PG&E Letter DCL-03-047

Docket No. 50-275, OL-DPR-80
Docket No. 50-323, OL-DPR-82
Diablo Canyon Units 1 and 2
Response to NRC Request for Additional Information Regarding License
Amendment Request 02-03, "Spent Fuel Cask Handling"

**PG&E Response to NRC Request for Additional Information Regarding License
Amendment Request 02-03, "Spent Fuel Cask Handling"**

Figure 1-1-2
(excerpted from DCCP FSAR Update Figure 9.1-3)

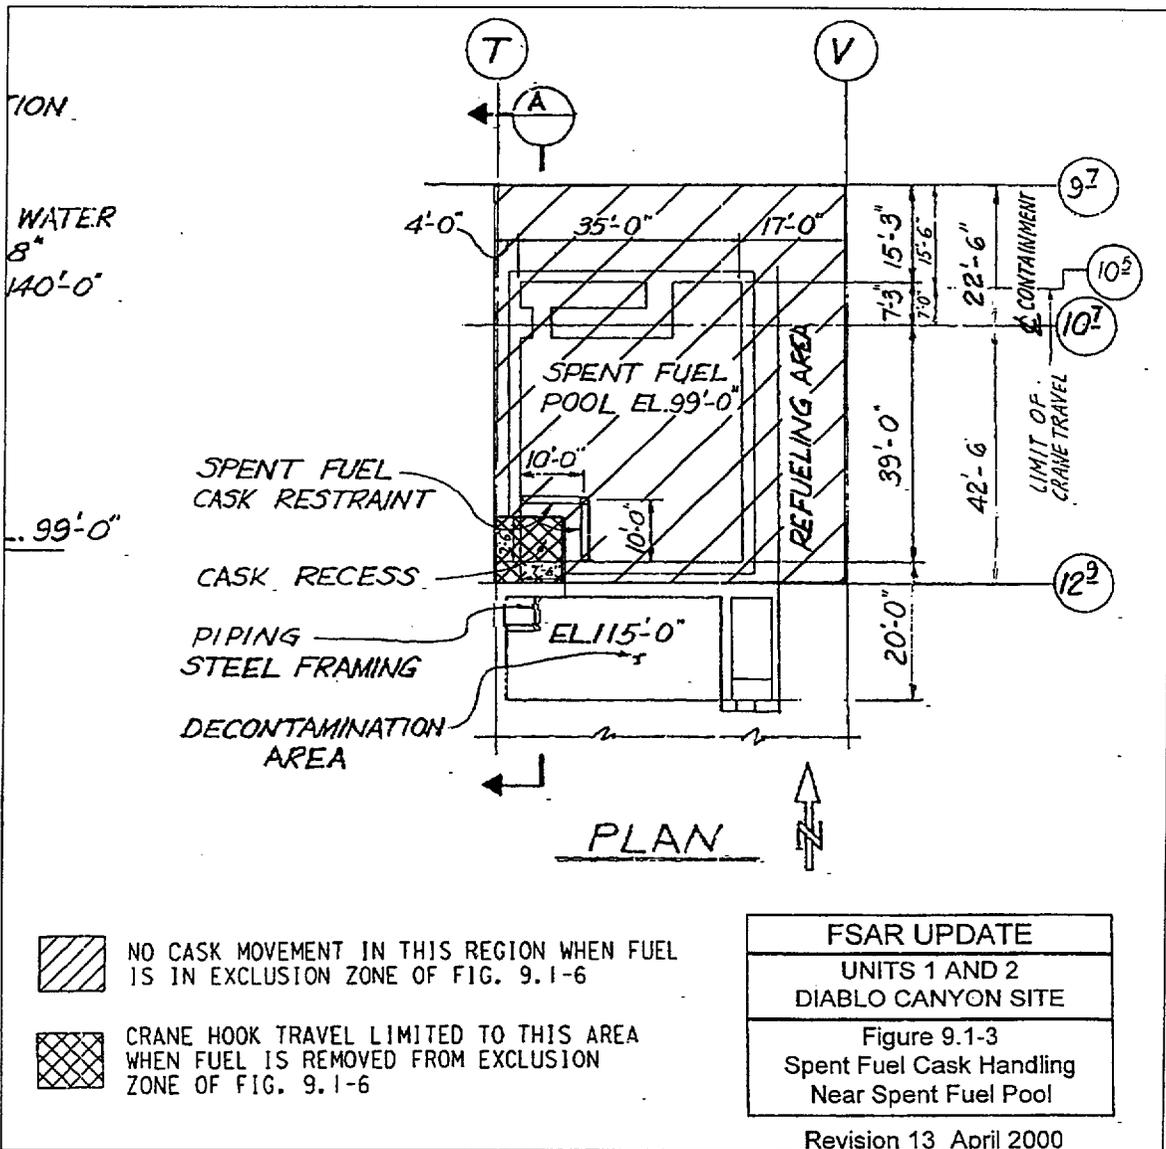
The Diablo Canyon Power Plant (DCPP) license amendment request to revise the DCPD updated final safety analysis report (UFSAR) regarding its control of heavy loads program proposes to eliminate the spent fuel cask exclusion zone. The UFSAR restricts cask movement to the portion of the spent fuel pool which is over the cask recess area. The defense-in-depth approach within NUREG-0612, "Control of Heavy Loads at Nuclear Power Plants," states that despite the increase reliability of the overhead handling system licensees should (1) provide sufficient operator training, handling system design, load handling instructions, and equipment inspection to assure

For clarification, PG&E does not intend to handle a spent fuel cask over any area of the SFPs other than the cask recess area as depicted in DCPD FSAR Update, Figure 9.1-3. The DCPD Control of Heavy Loads Program prohibits movement of all heavy loads over the SFP fuel storage racks unless specifically authorized by written procedures reviewed and approved by the PSRC. This program requirement is implemented in plant administrative controls by a "Heavy Load Exclusion Area". PG&E will not move the cask over the spent fuel storage racks, and the exclusion area over the fuel will not be eliminated.

Figure 1-4-1
Extension Link

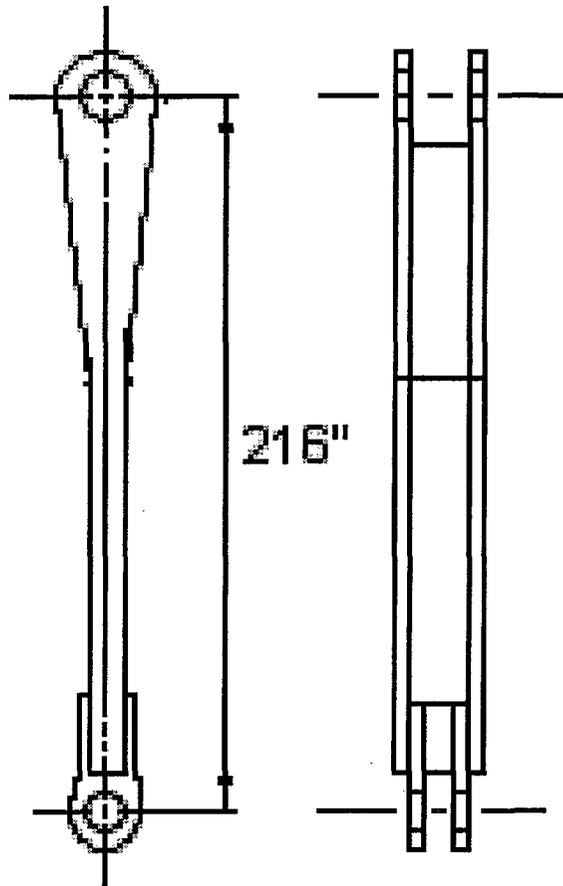
The auxiliary lift provides the overhead handling system with redundancy when used in heavy load handling operations. However, the submittal does not describe the design, testing, or inspection criteria for the auxiliary lift. Provide the design, testing, and inspection criteria applicable to the auxiliary lift and a description of the proof testing to completed at the manufacturers facility on the auxiliary lift to verify its ability to perform its intended function prior to the checking and testing performed at the place of installation.

The rigging between the auxiliary lift and transfer cask lift yoke is designed in accordance with applicable provisions of ASME B30.9 for the slings and ANSI N14.6 for the steel extension links (see Figure 1-4-1) used only for handling between the CWA and RSA locations. The rigid extension links (approx. 1,800 lb. ea.) are used in series with each sling from the auxiliary lift lifting beam to allow the sling to control the vertical displacement of the load during load transfer. Since the rigging to the cask lifting yoke is not redundant, a 10-to-1 factor of safety was used to select the slings per NUREG-0612 guidance, and the extension links are designed as special lifting devices per ANSI N14.6.

Figure 1-5-1
Fuel Handling Crane Load Paths

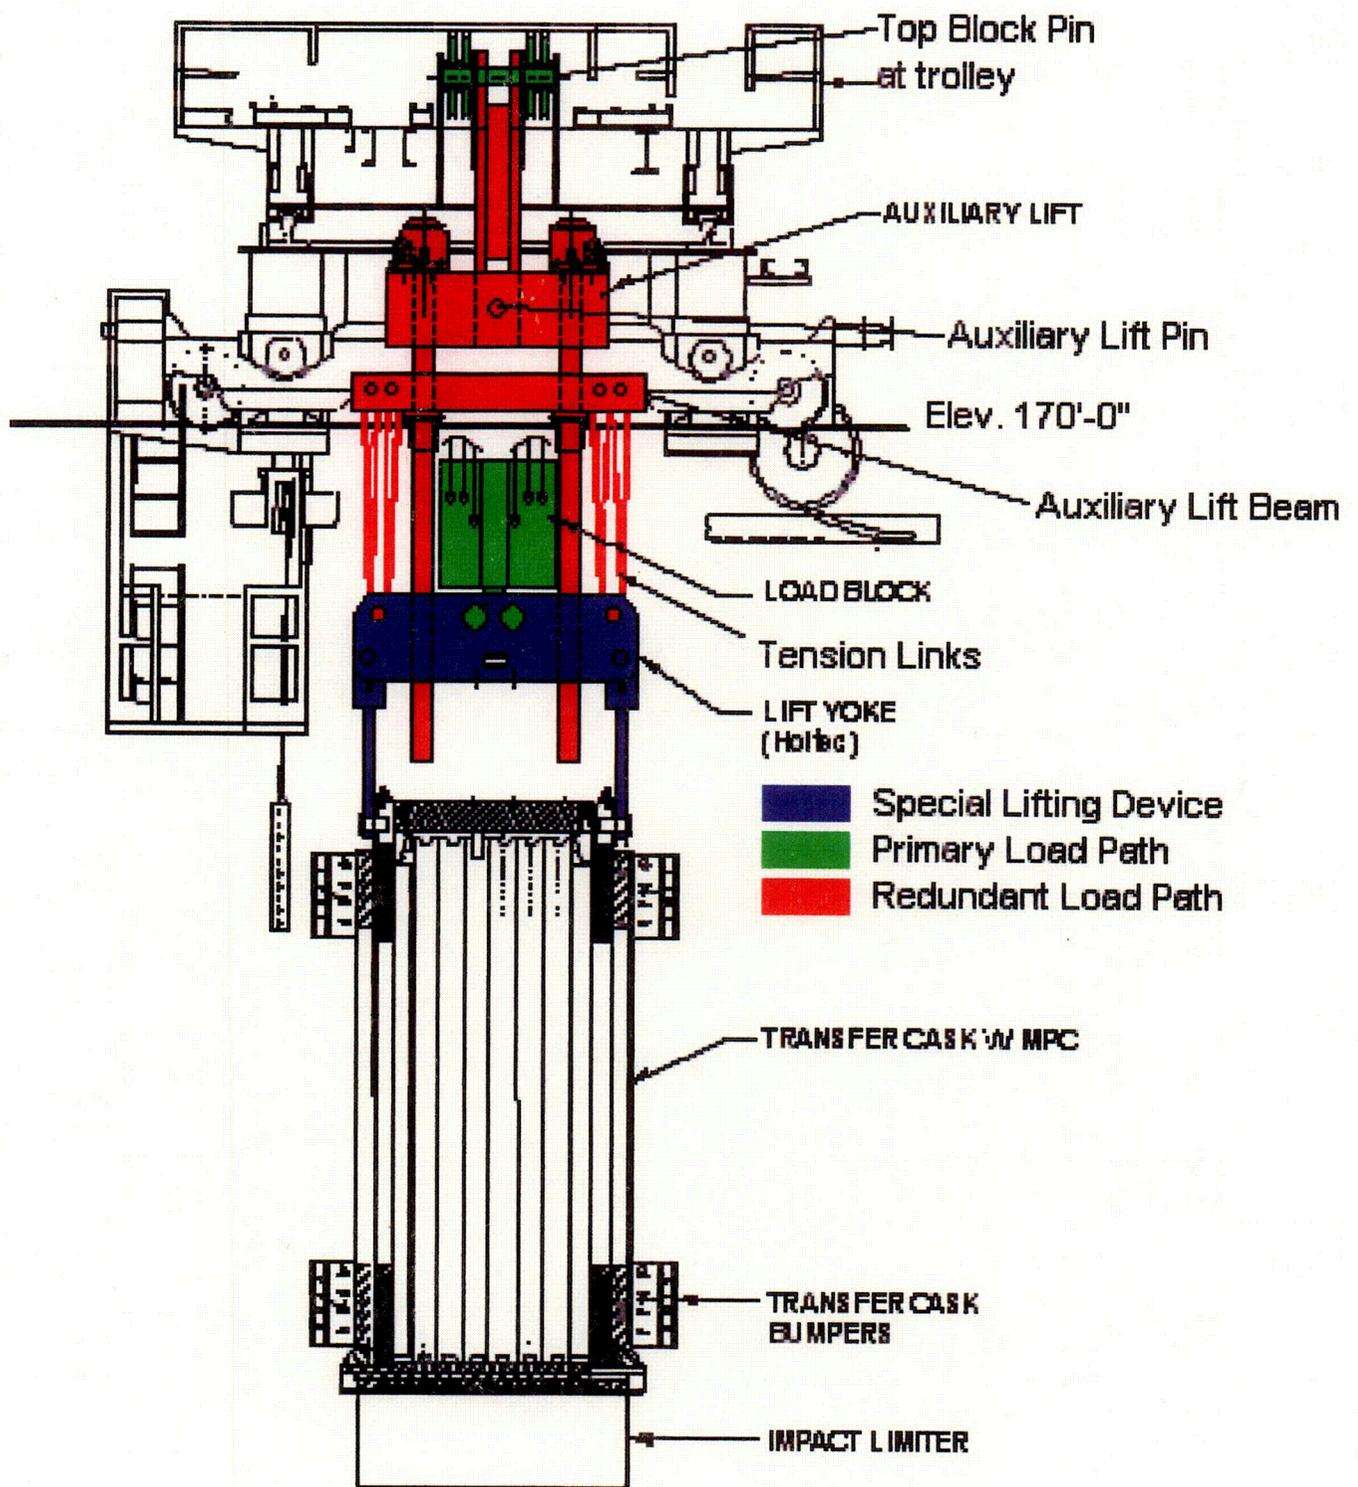
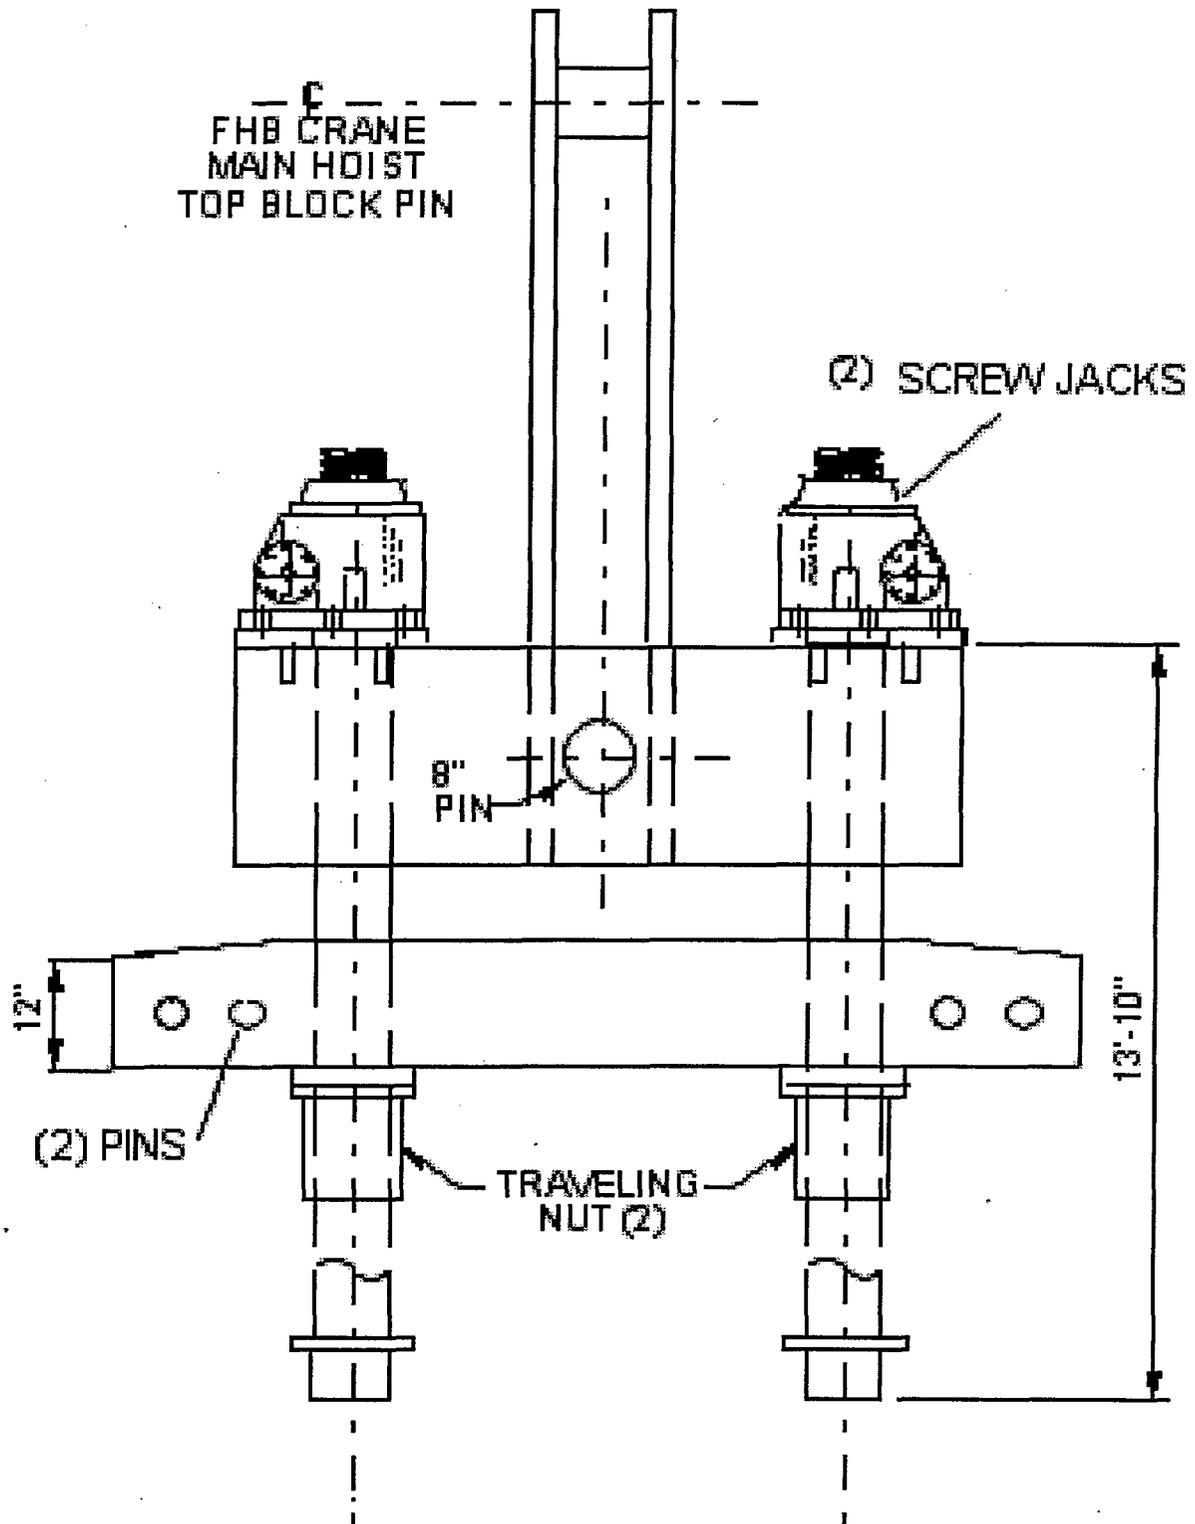
Although the original crane design was described in the December 5, 1984, NUREG-0612 submittal, describe how the auxiliary lift is design to move in the horizontal and vertical direction with respect to the crane bridge and trolley?

The auxiliary lift is an integral part of the crane trolley and moves horizontally with the crane trolley. Thus, east-west horizontal movement is accomplished by trolley movement along the girders of the FHB crane. North-south horizontal movement is accomplished by bridge movement along the FHB structure runway. Vertical movement of auxiliary lift lifting beam (approximately 96 inches) is provided by the rotation of the screw jacks. Coordination of the main hoist and auxiliary lift vertical movement is further described in response to NRC Question 1-6. During cask handling operations, the upgraded control system design of the FHB crane will be capable of prohibiting simultaneous, multi-axis load movement. One exception is the upending/downending operation of the transfer cask in the RSA on the cask transport frame where simultaneous trolley and main hoist operation is necessary.

The auxiliary lift is structurally attached to the trolley using the main hoist top block pin that also supports the main hoist sheaves.

See enclosed sketches of the trolley and auxiliary lift (Figures 1-5-1 and 1-5-2).
